Access Compliance Report

Public Rights-of-Way

Intersection ID: 10806	Main Street: MORSON_ST	Cross Street: STATE_ST	Location: SE
ADA ID: A9FF70390082	Ramp Type: Directional2	Initial Pass/Fail: Fail	Overall Compliance: No
Severity Score: 22.5			
Codes/Mitigation Info/Possible Solution		Field Measurements/Component Compliance

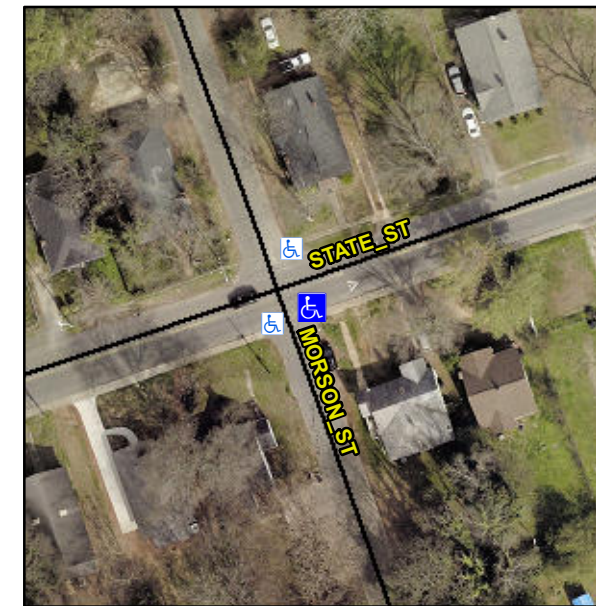
NO CURB

R304.5.1, R304.2.2, R304.5.3

Compliance	Description	Data	Compliance	Description	Data
N/A	Ramp Length (in)	63.0	N/A	Grade Break?	N/A
No	Ramp Width (in)	37.0	N/A	Grade Break Slope (%)	0.0
No	Ramp Slope (%)	10.0	N/A	Grade Break XSlope (%)	0.0
No	Ramp XSlope (%)	2.6			
N/A	Flare Type LT	N/A	N/A	Flare Type RT	N/A
N/A	Flare Slope LT (%)	N/A	N/A	Flare Slope RT (%)	0.0
N/A	Flare Traversable LT?	N/A	N/A	Flare Traversable RT?	N/A
N/A	Landing Length (in)	0.0	N/A	DWS Provided?	N/A
N/A	Landing Width (in)	0.0	N/A	DWS Contrast?	N/A
N/A	Landing Slope (%)	0.0	N/A	DWS Length (in)	N/A
N/A	Landing X Slope (%)	0.0	N/A	DWS Full Width?	N/A
N/A	Landing Curb? (Y/N)	N/A	N/A	DWS Offset LT (in)	N/A
N/A	Shared Landing?	N/A	N/A	DWS Offset RT (in)	N/A
N/A	Gutter Ponding?	0.0	N/A	Gutter Slope (%)	N/A
N/A	Gutter Lip Ht (in)	0.0	N/A	Gutter X Slope (%)	N/A
N/A	Painted X Walk1?	No		Road Slope (%)	4.3
	X Walk 1 Direction	To W		Road X Slope (%)	7.4
	X Walk 1 Width (in)	N/A		Clear Space?	N/A

Remove & Replace Entire Ramp.
